From: BRYAN BUTCHER [REDACTED]
Sent: 08 June 2022 18:50:37
To: Hannah Kersley
Cc:
Subject: Re: AW/132/22/HH
Attachments: 6, The Pound Planning Application Supp..pdf; No7 .jpeg; No 5 .jpeg

I'm emailing regarding the application for an extension at 6 The Pound, Aldwick (AW/132/22/HH). Would it be possible to have a 45 / 60 degree line added to the proposed plans? We mainly need this taken from No.7 as this appears to be the property most at risk of impact from the proposal.

PROPOSED SINGLE STOREY EXTENSION AT 6, THE POUND, ALLOWICK
FOR MISS. E. SHADBOLT.

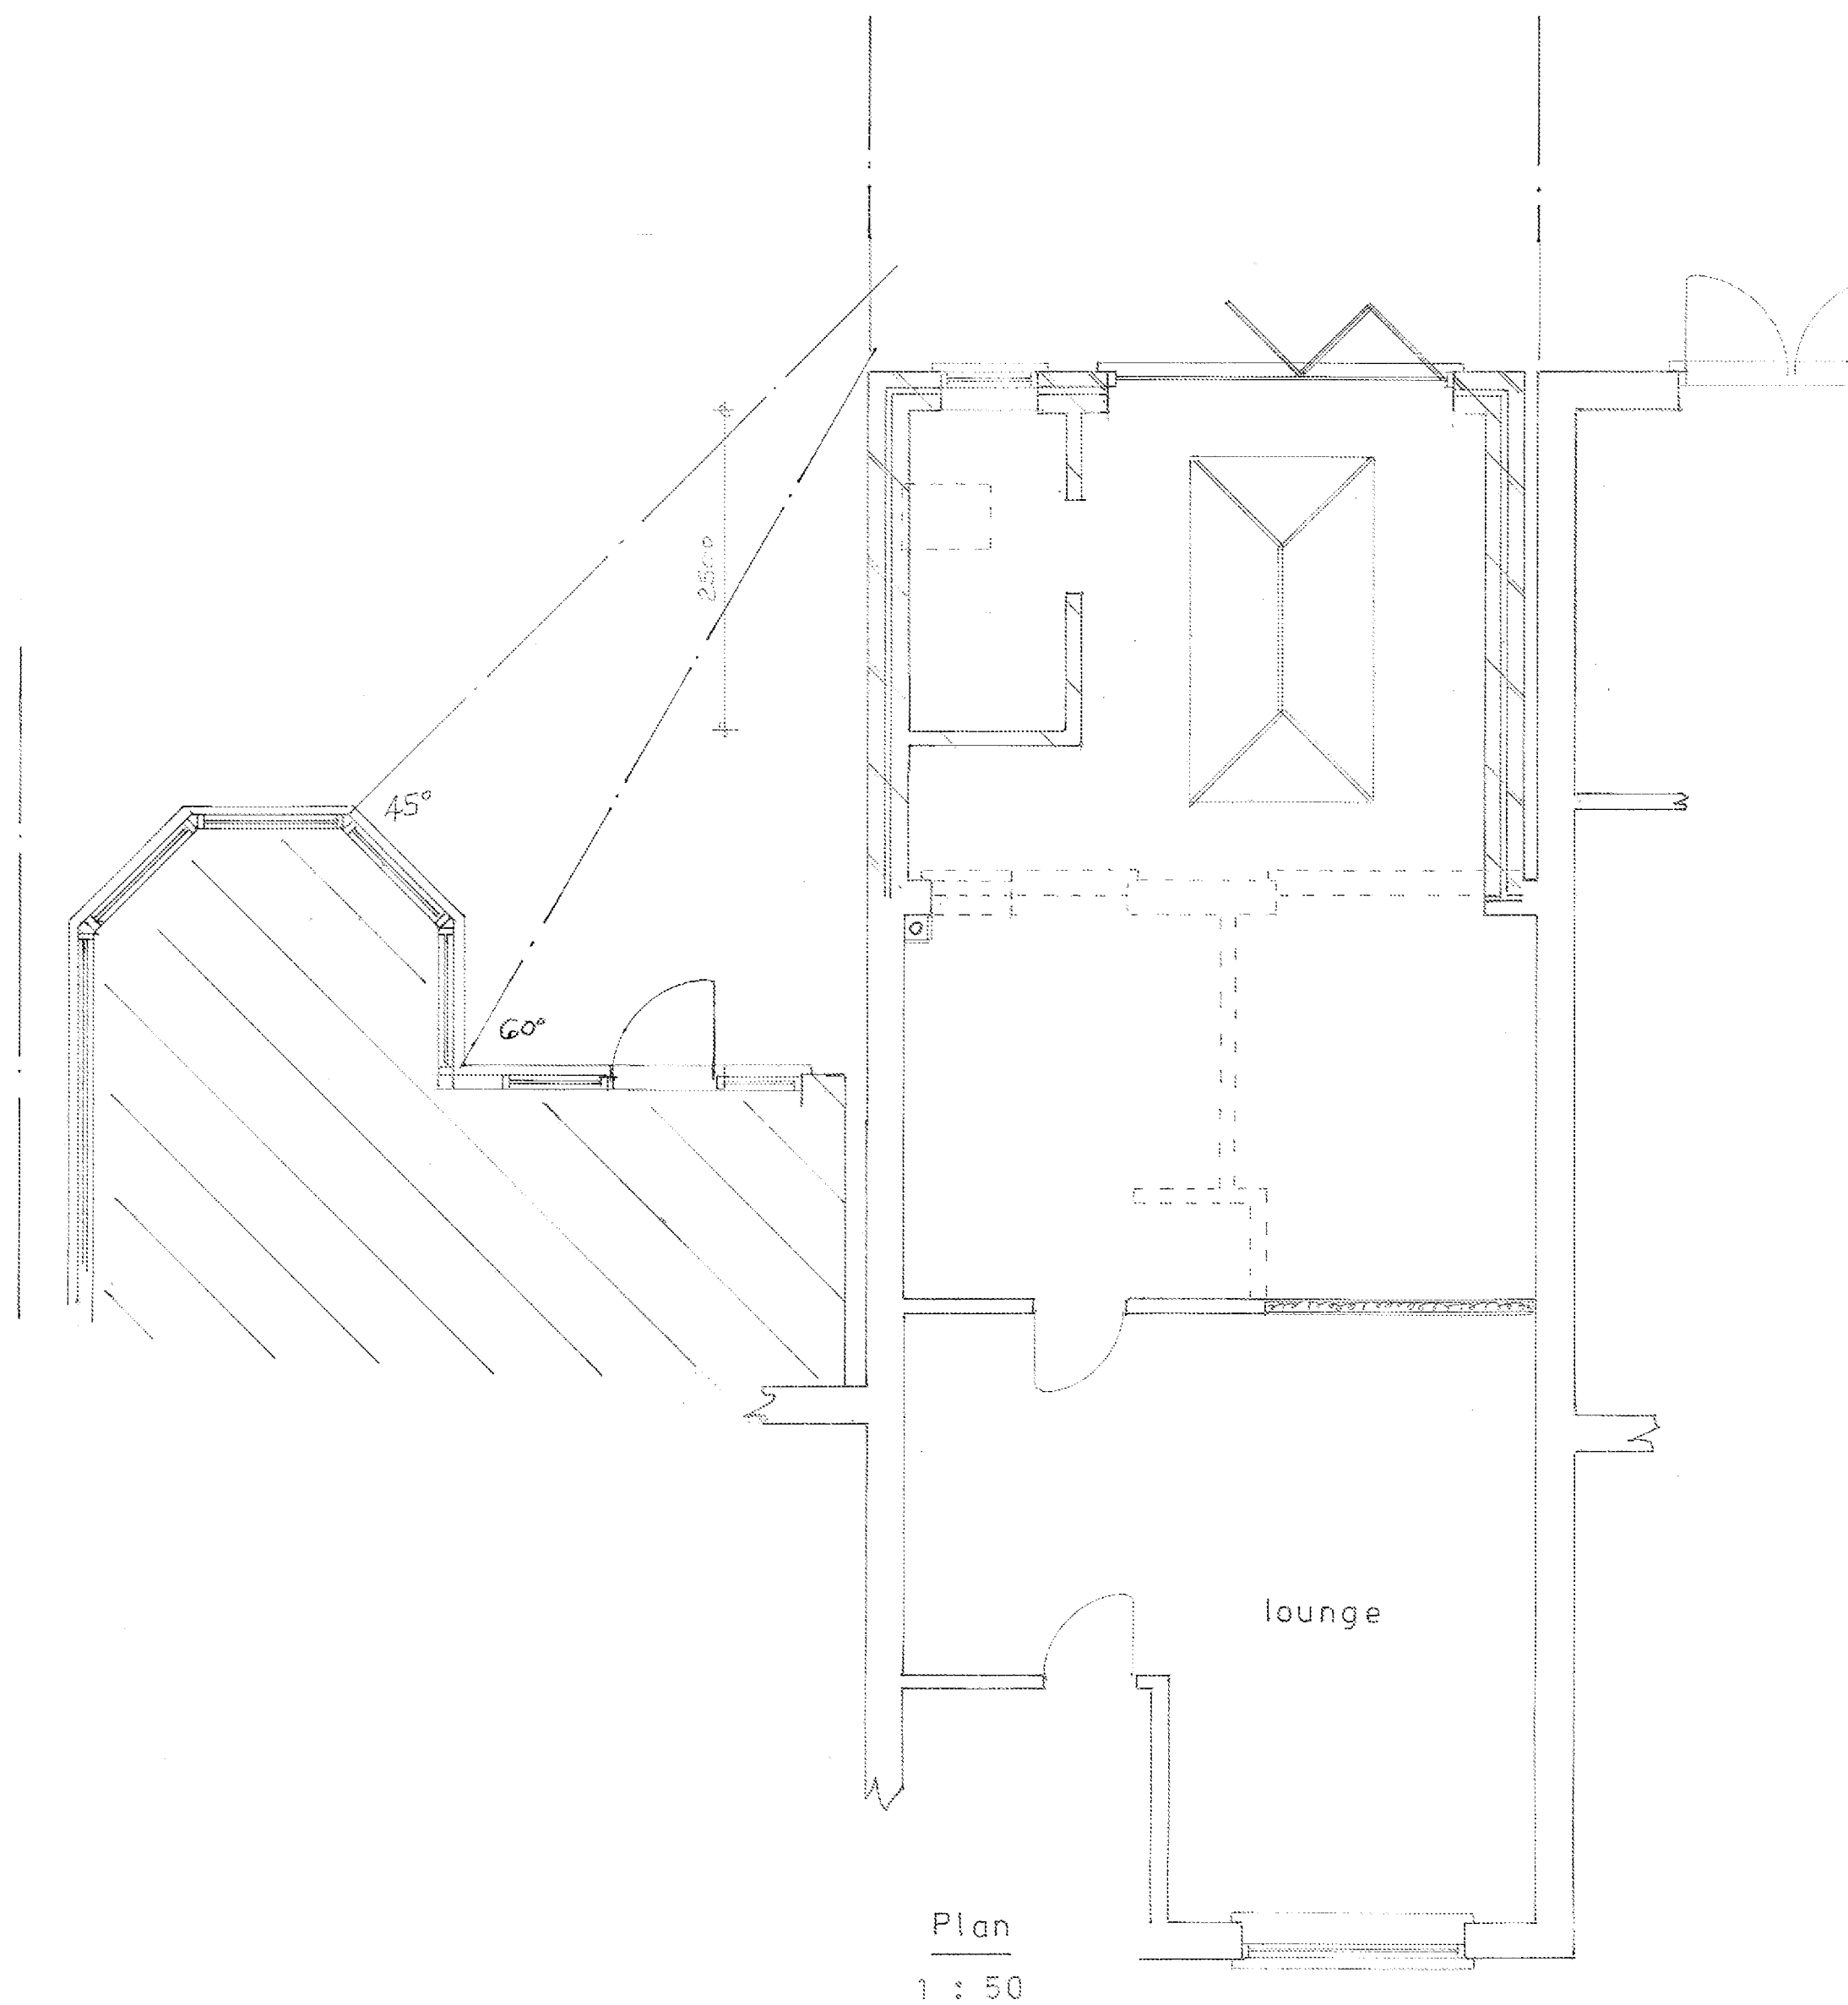
Given the shape of next doors conservatory it's not easy to determine the correct 45 and 60 degree angles as you will note.

'Snooping' through the neighbour's conservatory windows on the photograph it would appear that the angled part of the conservatory is used as the sitting area with the other part, nearer our proposal, used for more practical purposes.

I am pleased to attach a supplementary plan and photos as requested.
